To: T10 Technical Committee
From: Steven Fairchild, HP (steve.Fairchild@hp.com)
Date: 1 October 2002
Subject: Expander Configuration Details

The purpose for this document is to define the topology addressing details for the edge and fanout expanders. Most of the wording is to clarify existing concepts, with the exception of a new section on configuration of expander route tables within edge and fanout devices.

Figure X – Edge expander device set

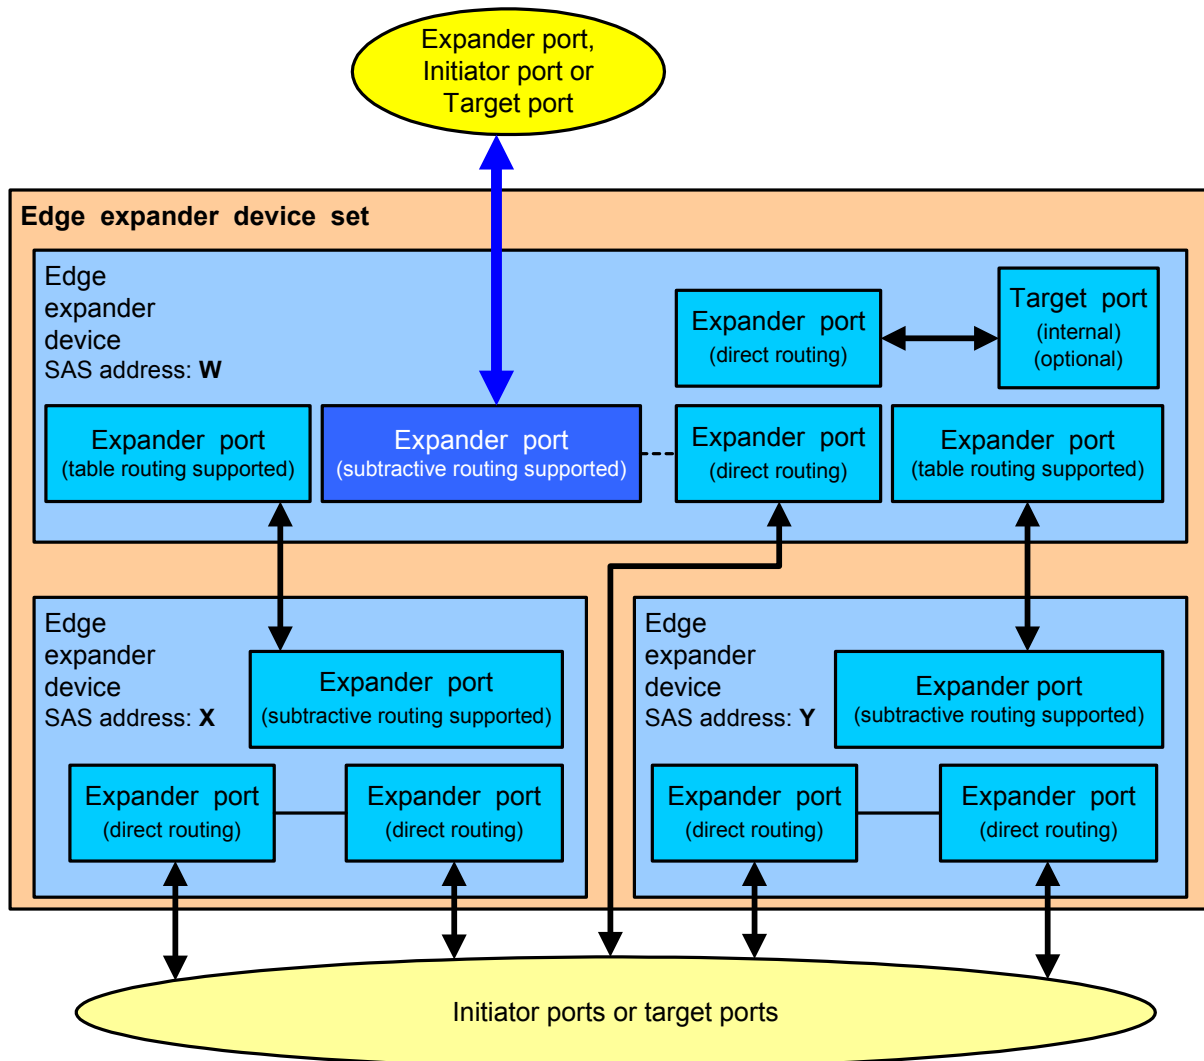
Figure X shows an edge expander device set.

4.1.7.1 Edge expander device set

Edge expander devices may be grouped into edge expander device sets. The edge expander device sets are bounded by the direct routing phys attached to end devices and the phys supporting subtractive routing that are:

- a) Attached to the phys of a fanout device; or,
- b) Attached to the phys supporting subtractive routing on another edge expander device set; or,
- c) Attached to an end device.

The table routing phys of an edge expander device provide attachments to other edge expander devices in the edge expander device set.

The number of initiator devices and target devices attached to an edge expander device set may not exceed the maximum number of initiator devices and target devices for an edge expander device (see 4.1.9).

Figure 13 – Maximum expander topology

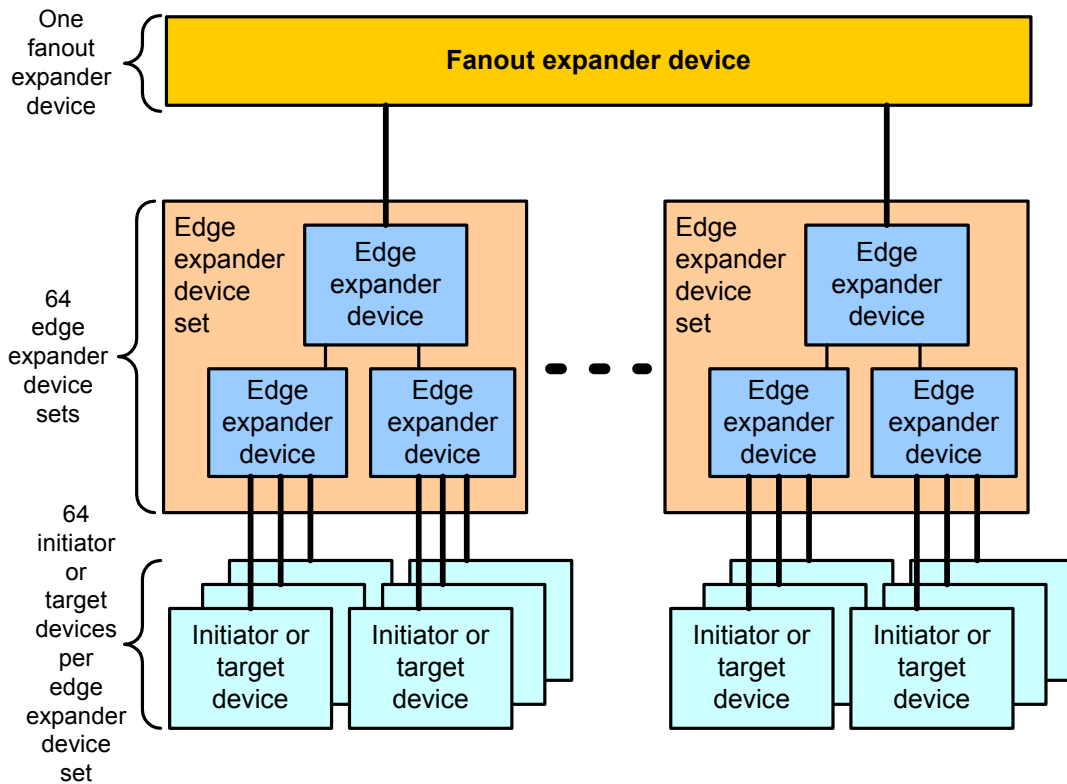
Figure 13 shows a SAS domain with the maximum number of expander devices.

No more than one fanout expander device shall be included in a SAS domain. The fanout expander device may be attached to up to 64 edge expander device sets, initiator devices or target devices.

Each edge expander device set may be attached to no more than one fanout expander device. Each edge expander device set may be attached to up to 64, initiator devices or target devices.

An edge expander device set may be attached to another edge expander device set only if there are no other expanders in the SAS domain.

Figure 14 – Fanout expander topology

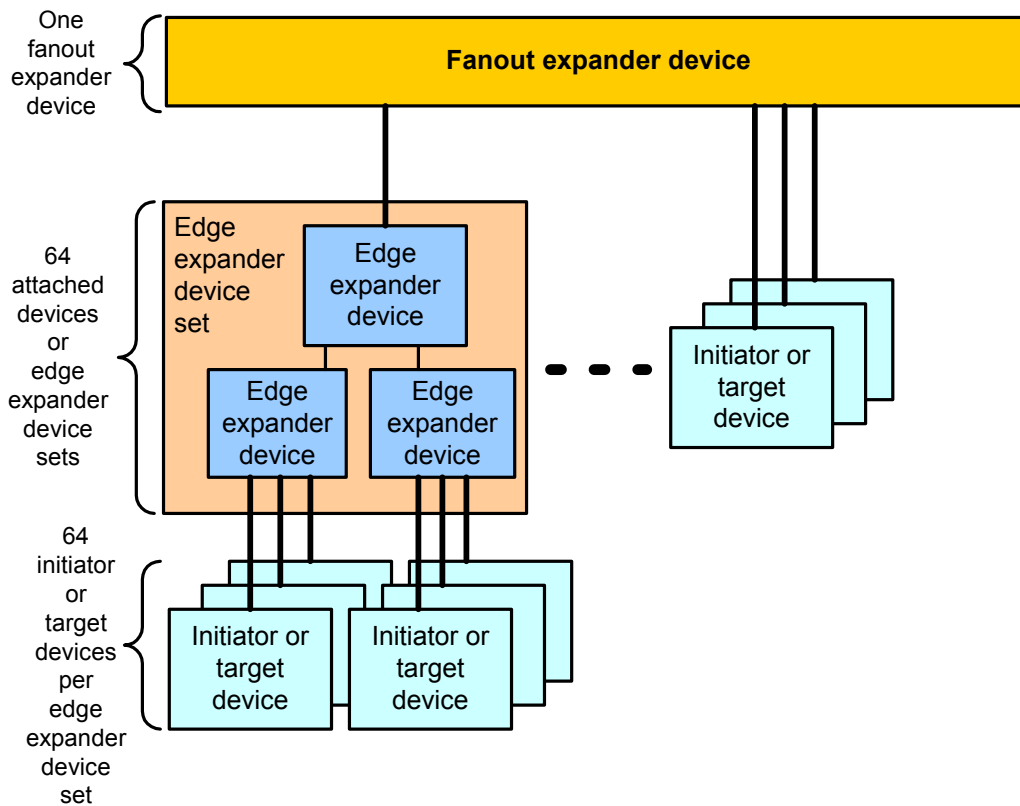
Initiator devices and target devices may be attached directly to the fanout expander device, as shown in figure 14.

Figure 15 – Edge expander device set topology

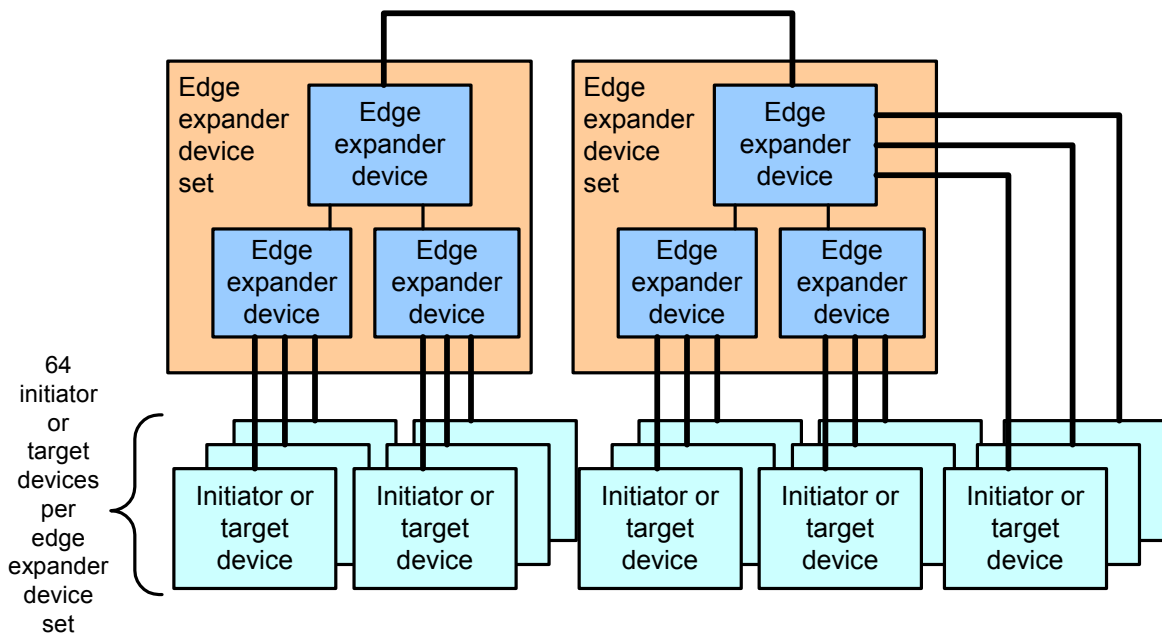
Initiator devices and target devices may be attached to any of the edge expander devices within an edge expander device set and at most, two edge expander device sets may be attached together without a fanout expander, as shown in figure 16.

Figure X – Expander route table example

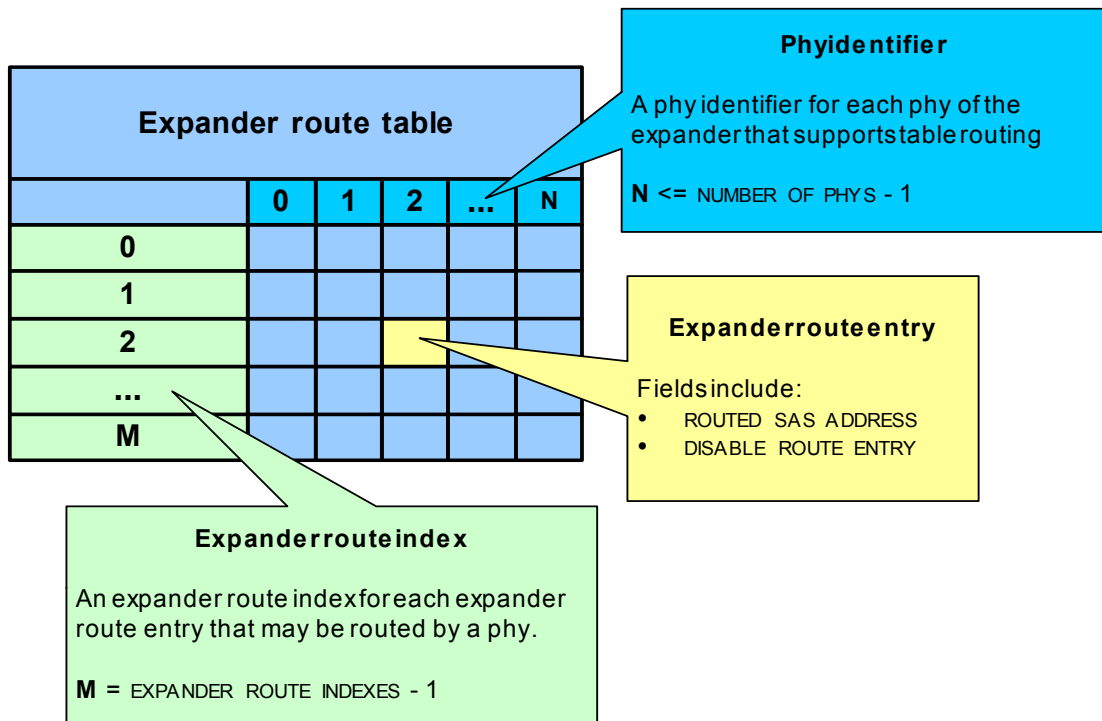
Figure X shows a logical representation of an expander route table with the elements identified.

An expander device that supports the table routing method (see 4.1.9.1) shall contain an expander route table. The expander route table is an organized structure that provides an association between destination SAS addresses and expander phy identifiers. Each association is an expander route entry.

An expander device may indicate its capability of maintaining the expander route entries by the CONFIGURABLE ROUTE TABLE field in the SMP REPORT GENERAL response (see 9.4.4.2).

The NUMBER OF PHYS and EXPANDER ROUTE INDEXES fields in the SMP REPORT GENERAL response (see 9.4.4.2) define the size of the expander route table.

An initiator device references a specific expander route entry within an expander route table by using the PHY IDENTIFIER and EXPANDER ROUTE INDEX fields in the SMP REPORT ROUTE INFORMATION (see 9.4.4.5) or SMP CONFIGURE ROUTE INFORMATION (see 9.4.4.9) functions.

Figure Y – Expander route index order

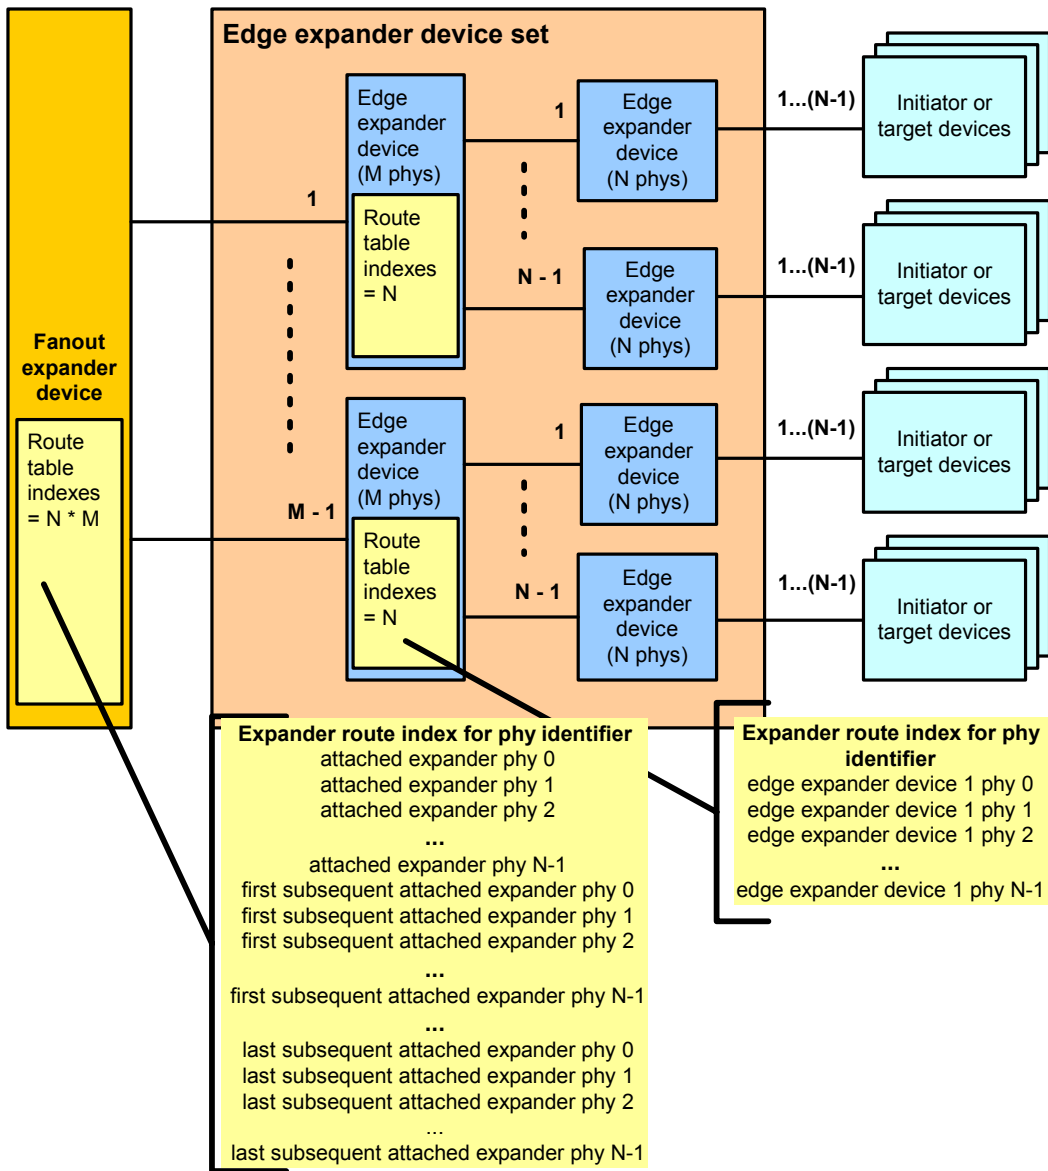
The order of the expander route entries in the expander route indexes is deterministic based on the topology. Figure Y shows the expander route index order.

The number of devices attached to edge expander device sets and to the fanout expander determines the maximum extent of the SAS domain (see 4.1.9). The number of phys necessary to support the maximum device count within the SAS domain is less deterministic, since it depends on the number of wide ports and the number of phys within each wide port.

To avoid an overflow of an edge expander route index during the discovery process (see 4.1.9.2) the minimum number of edge expander route indexes per phy identifier shall be greater than or equal to the sum of all downstream edge expander device phys addressable through the **edge expander device** phy.

To avoid an overflow of the fanout expander route index during the discovery process (see 4.1.9.2) the minimum number of fanout expander route indexes per phy identifier shall be **the sum of all downstream edge expander device phys within an attached edge expander device set.**

Figure X – Expander topology example

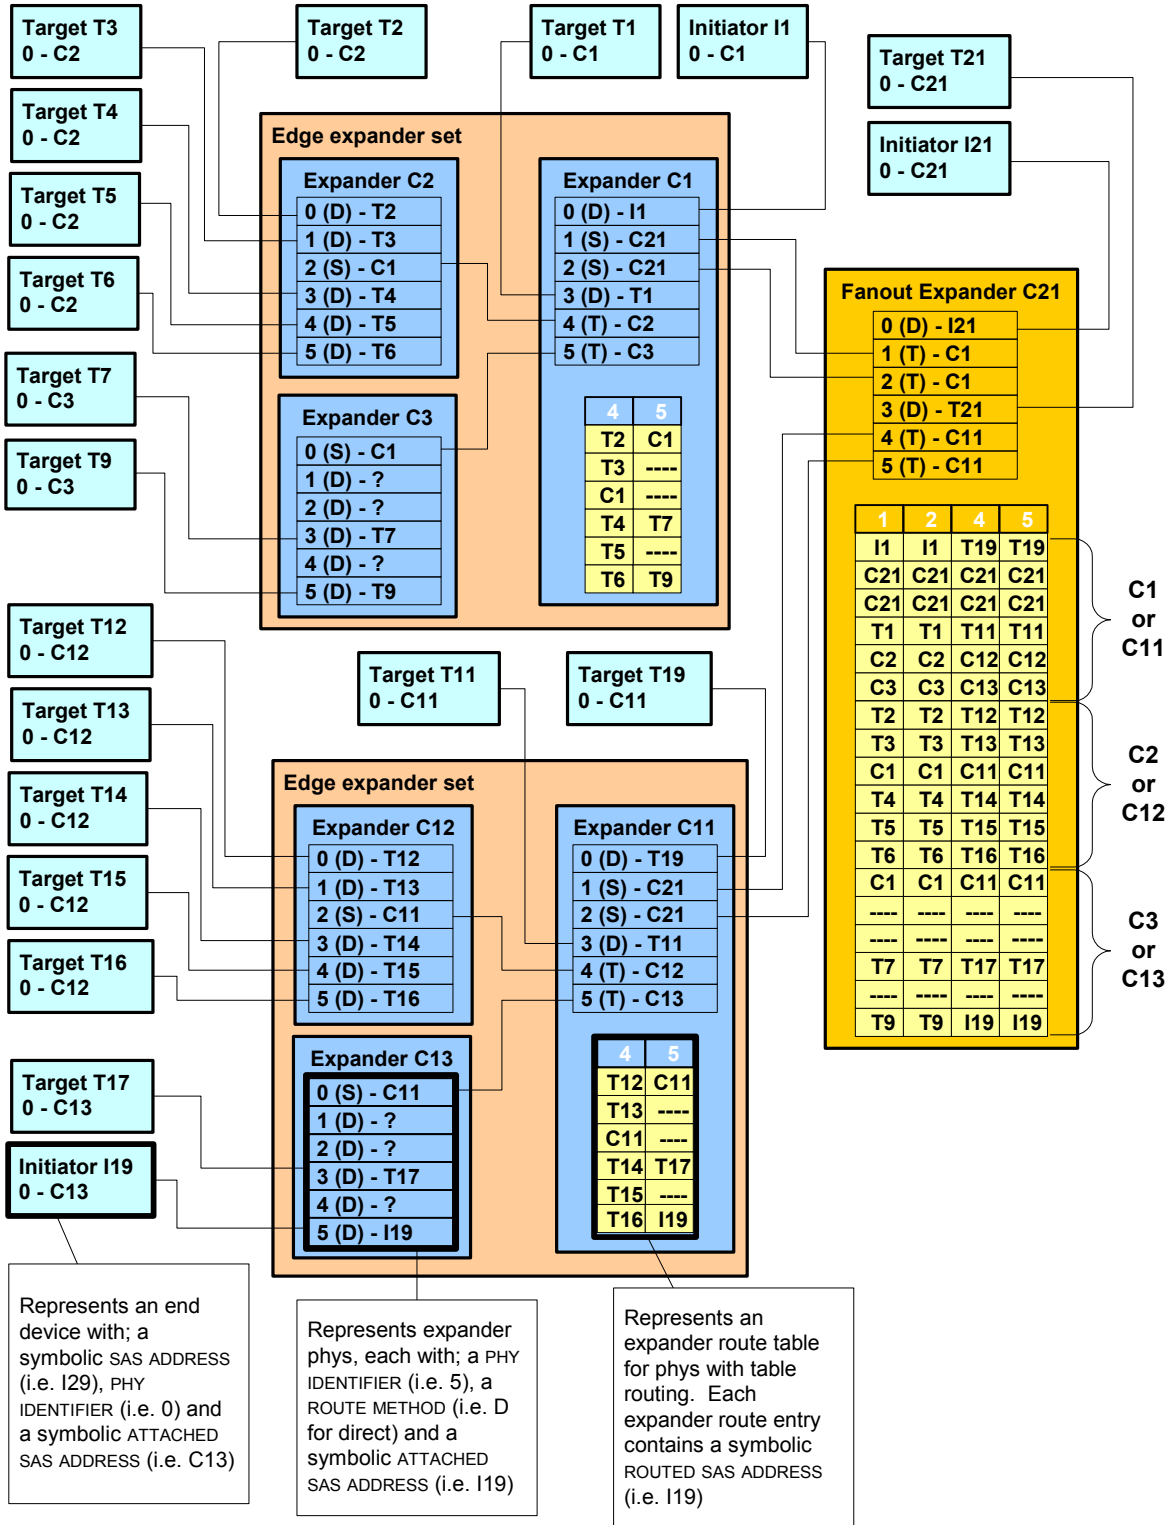
Figure X shows an example topology, which is used to describe the discovery process.

Using Figure X as an example, the application client within initiator device (I1) shall have completed the equivalent of Table X after traversing the edge expander device set with edge expander device members, C1, C2 and C3.

Using Figure X as an example, the initiator device (I21) shall have completed the equivalent of Table Y after traversing the fanout expander (C21) and encountering the configurable edge expander device sets (C1, C2, C3 and C11, C12, C13).
